Revision: Issue 1
Date: 16th June 2014

Universal Menswear Ltd.

Plot 234-238, 252-254, Adamjee EPZ, Narayanganj
(23.676969, 90.518717)
7th June, 2014

Structural Inspection Report

Cross bracing elements missing or modified

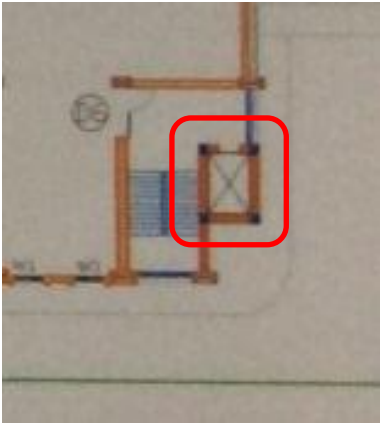
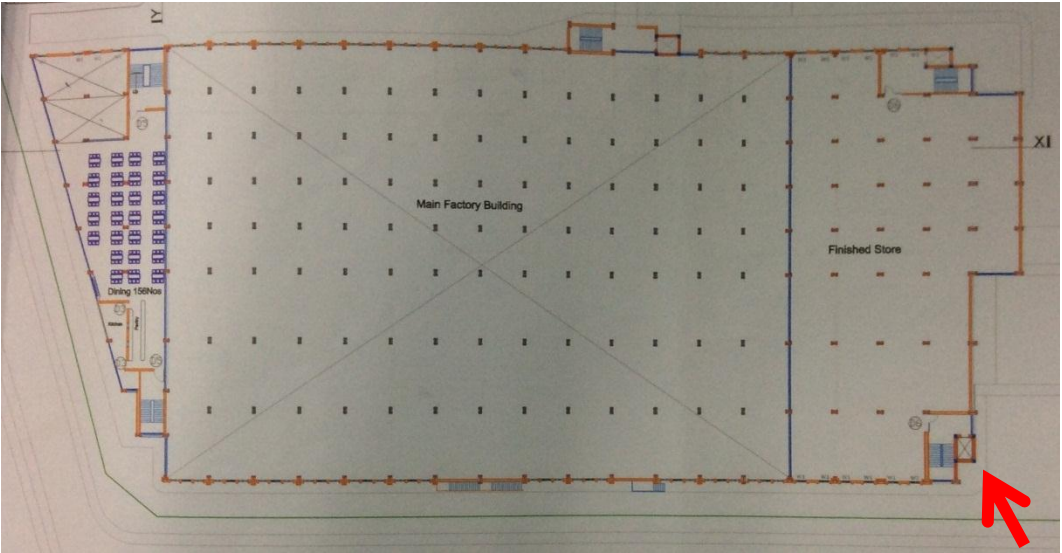
Example of modified cross bracing connection

Example of cross bracing omitted on account of door

- In a number of locations throughout Building 1, cross bracing elements were either missing, or had end connections which were cut, missing bolts or misaligned

- Building Engineer to assess the as-built bracing to BNBC and modify if required

Cracking observed to brick perimeter walls

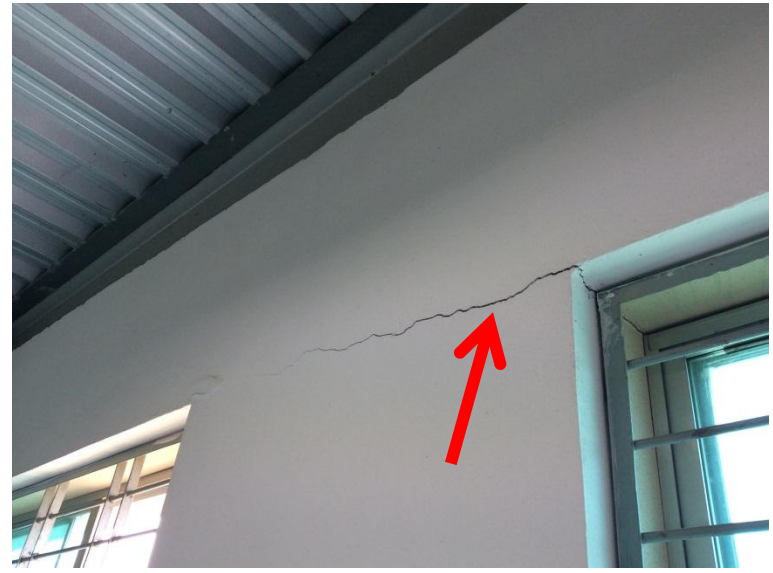
Examples of cracking to brick walls

Examples of cracking to brick walls

- Building engineer to record all cracking throughout factory compound and monitor on an on-going basis
- If further cracking occurs Building Engineer to investigate and remediate as appropriate

Unclear lateral support to tops of brick walls

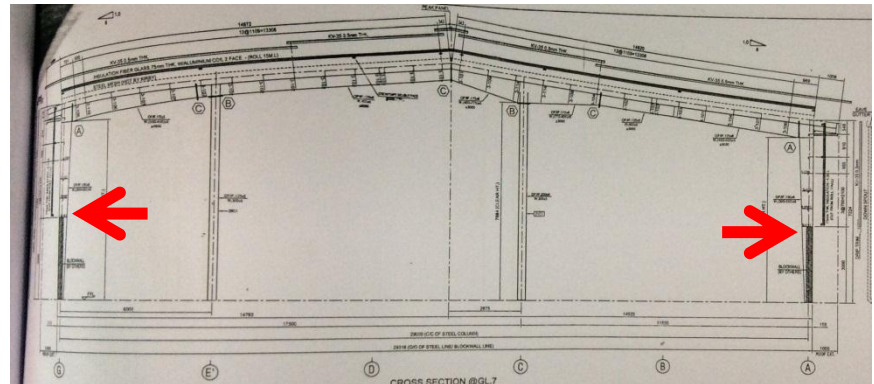
As constructed, lateral support to tops of brick walls is not clearly defined

As constructed, lateral support to tops of brick walls is not clearly defined

- Building engineer to verify stability of brick walls according to BNBC and modify if necessary

Footings to external stairs are settling

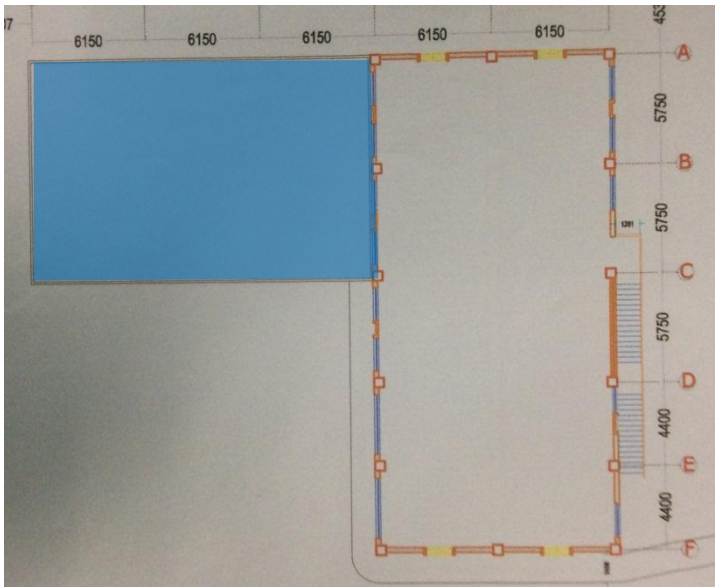
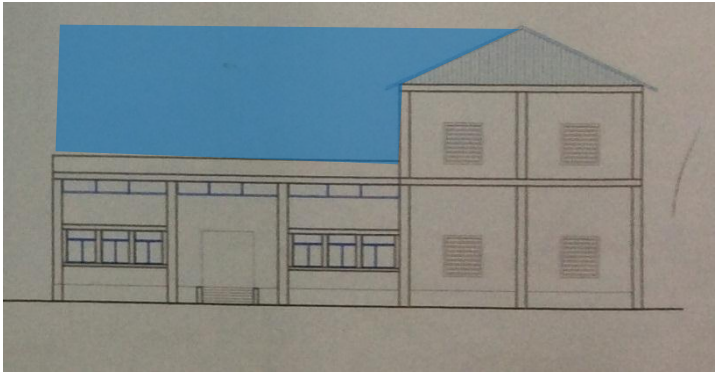
Settlement of ground beneath shallow footings to stairs

Failure of shallow footing to stairs

- Building footing system is piled, external stair footing system appears not to be piled
- Differential settlement and cracking of stair footings observed
- Subsequently, steel frames to stairs are deformed
- All external stairs to Buildings 1 and 3 are similarly affected

- Building Engineer to assess safety of external stairs , and effects on main building structure
- As appropriate, limit access and consider providing temporary propping system

- Building Engineer to implement a permanent solution to stairs footings settlement issue

Roof structure added beyond permit drawings

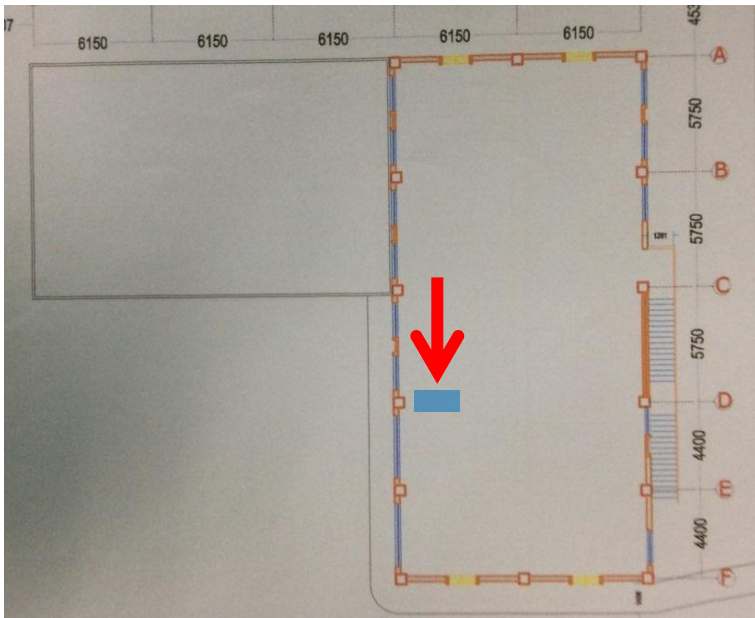
- An enclosed extension has been constructed over a portion the mezzanine floor
- Extension is not documented on permit drawings and engineering design drawings

(A) Lateral stability system to roof frame is not clearly defined – absence of roof cross bracing and wall cross bracing
(B) Unclear portal frame action, column-to-truss connection details appear non-engineered
(C) Purlin lateral torsional buckling observed

- Building engineer to prepare a set of as-built drawings for all structures linked to the factory's activities. Permit documentation and drawings also to be prepared
- Building Engineer to assess stability of roof frame and capacity of connections under horizontal and vertical loading to BNBC and make all necessary alterations

Lift core converted to storage

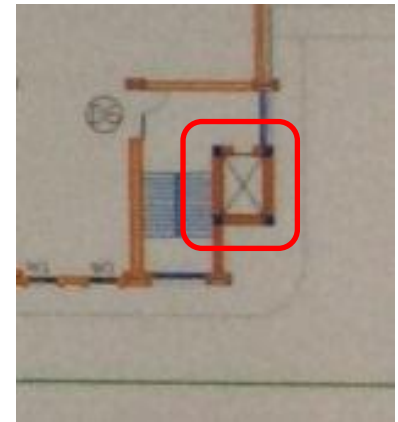
Lift core converted to storage at all building levels, using steel beams supporting RC floor slabs

- Building Engineer to assess the as-built construction to BNBC and modify if required
- Building Engineer to carry out as-built survey of converted area and produce accurate complete as-built drawings
